H-11097

## DESCRIPTIVE REPORT

*General Locality* ..... Kasaan Bay

*Sublocality* ..... Grindall Island to Kasaan Peninsula

*AWOIS item 52761, 2002 bathymetry and 2002 search position; Chart 17426*

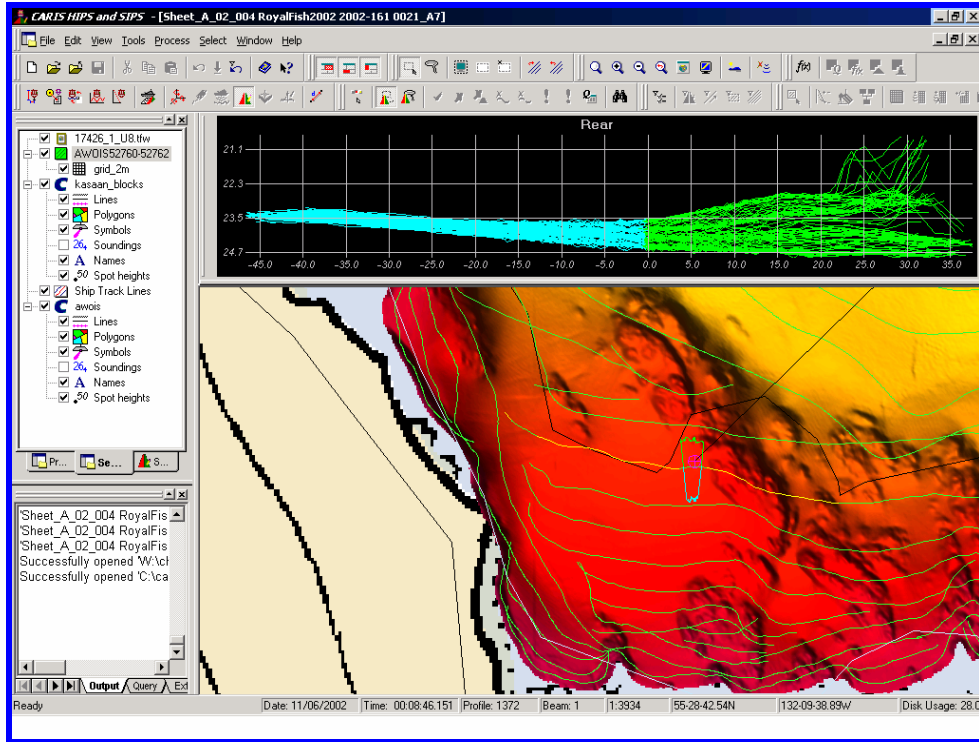
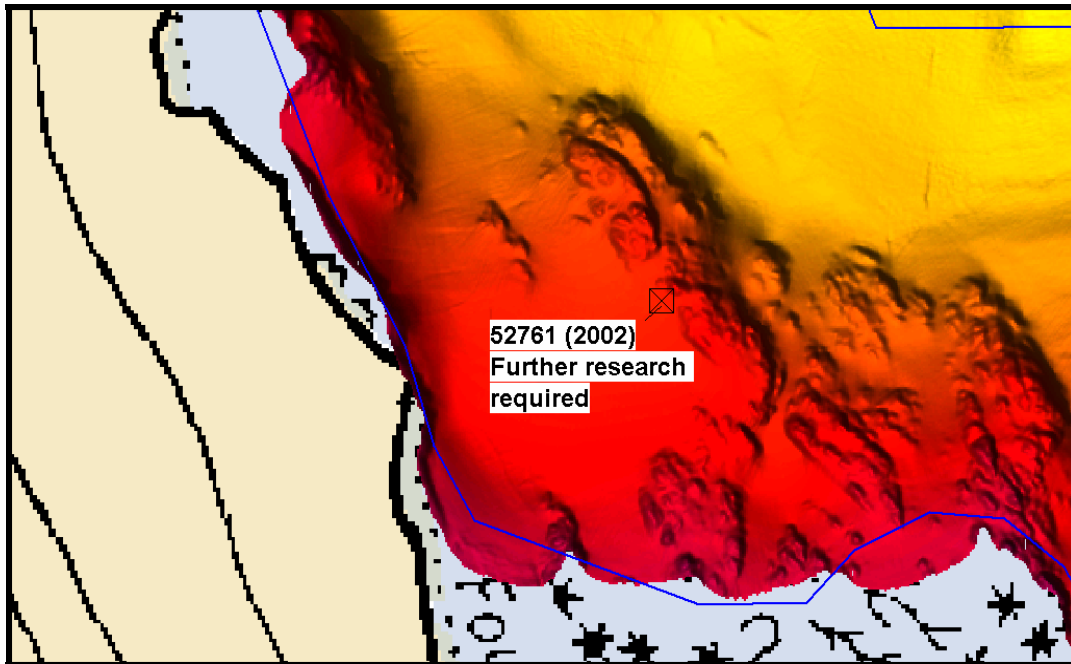
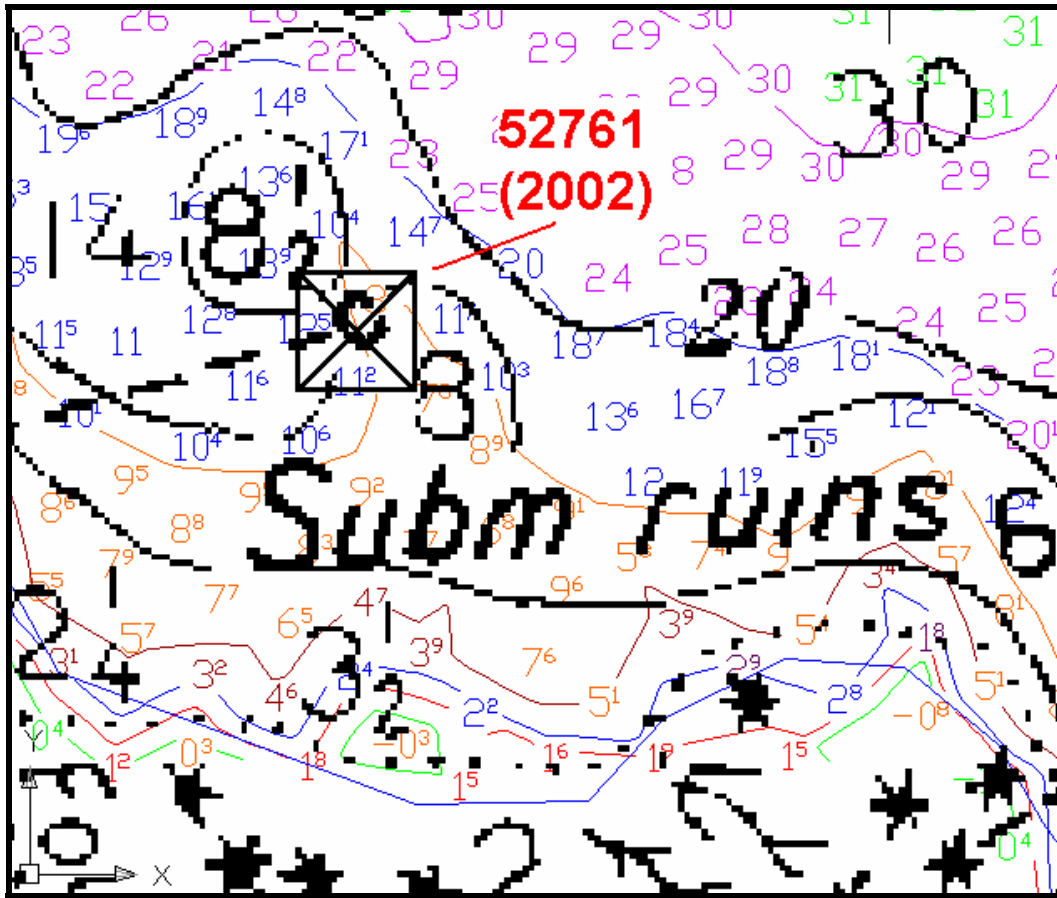
Investigation Summary: The search area has 200% SWMB coverage. A review of the digital terrain model detected some topographic relief. A review of the bottom profile in CARIS did not show any obvious evidence of ruins. Further investigation with divers or SS sonar would be required to determine if these ruins still exist.

Evaluator comment: The hydrographer found no conclusive evidence of ruins, and PHB review of the data  
 showed no evidence of the ruins. Smooth sheet portrayal of the ruins originated from the chart, not the survey. The evaluator  
 recommends removing submerged ruins symbol and notation from all affected charts. Chart the area according to survey H11097.

<sup>52</sup> Do not concur. The ruins symbol portrayed on the smooth sheet originated from the chart and is not source information from the present survey. The ruins are not evident in the DTM or smooth sheet. The evaluator recommends removing the charted ruins symbols and *subm ruins* notation. Chart least depth of 8 fathoms 4 feet as *Rk*, as depicted on the Hdrawing and smooth sheet. See AWOIS report attached to this report.

*AWOIS item 52762, 2002 bathymetry and 2002 search position; Chart 17426*

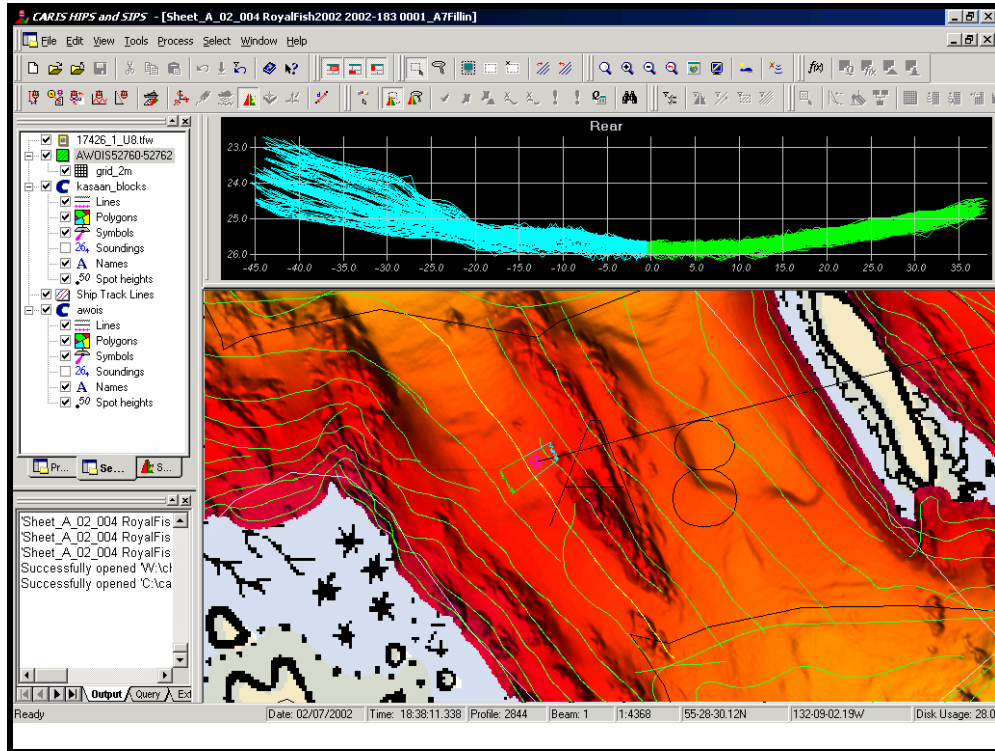
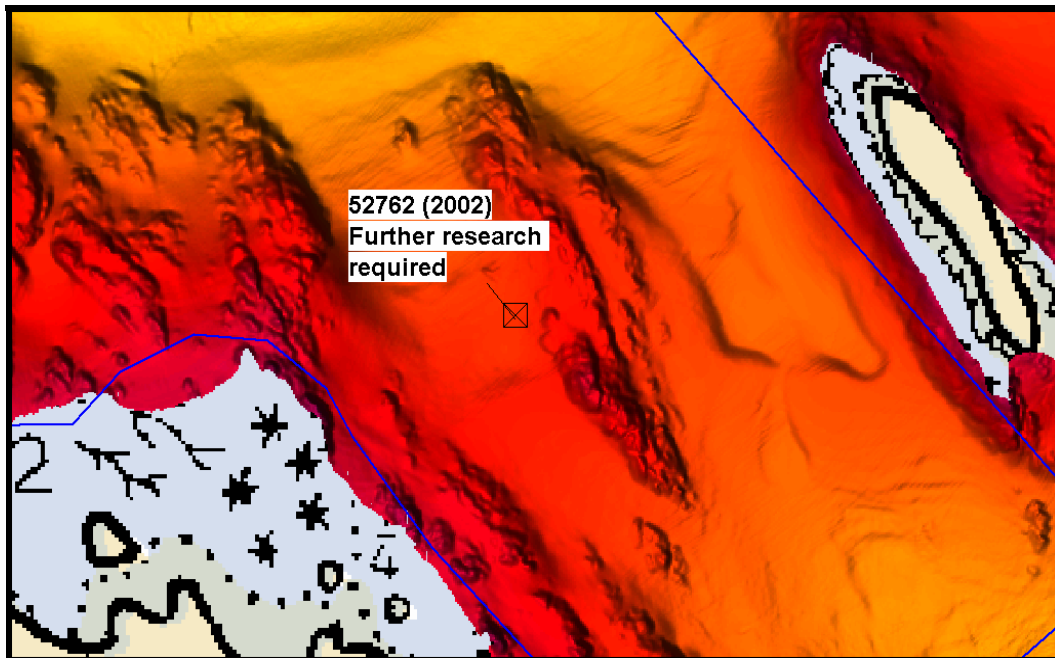
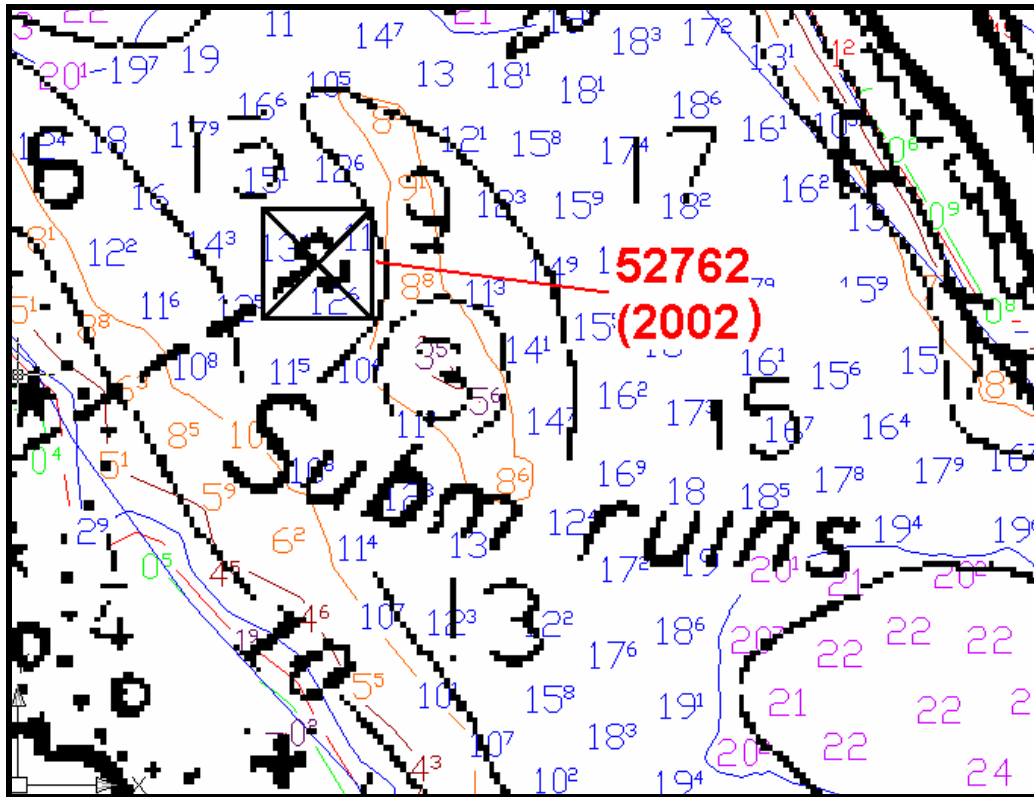
Investigation Summary: The search area has 200% SWMB coverage. A review of the digital terrain model detected some topographic relief. A review of the bottom profile in CARIS did not show any obvious evidence of ruins. Further investigation with divers or SS sonar would be required to determine if these ruins still exist.

Proprietary  
 Evaluator comment: Evaluator comment: The hydrographer found no conclusive evidence of ruins, and PHB review of the data showed no evidence of the ruins. Smooth sheet portrayal of the ruins originated from the chart, not the survey. The evaluator recommends removing submerged ruins symbol and notation from all affected charts. Chart the area according to survey H11097.

<sup>53</sup> Do not concur. The ruins symbol portrayed on the smooth sheet originated from the chart and is not source information from the present survey. The ruins are not evident in the DTM or smooth sheet. The evaluator recommends removing the charted ruins symbols and *subm ruins* notation. See AWOIS report attached to this report.

Portion of Chart 17420 showing the misspelling of geographical names

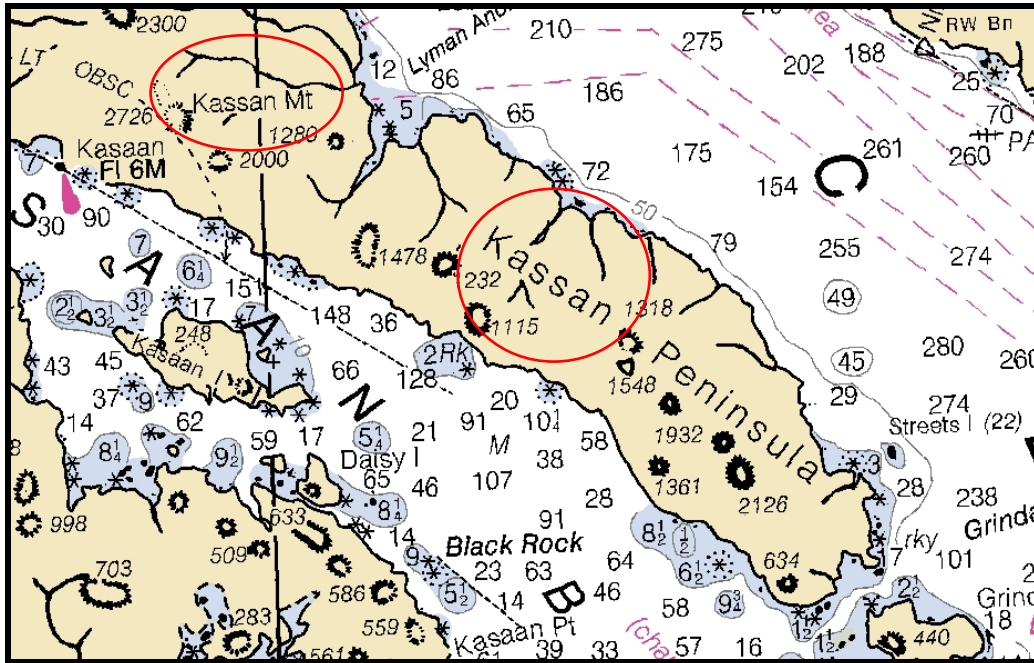
The geographic names Kasaan Peninsula and Kasaan Mountain were found to be misspelled as *Kassan Peninsula* and *Kassan Mountain* on Chart 17420. Local knowledge and all other references found for the area support the proper spelling as Kasaan Peninsula and Kasaan Mountain.<sup>73</sup>

<sup>73</sup> Concur. Correct spelling on Chart 17420.
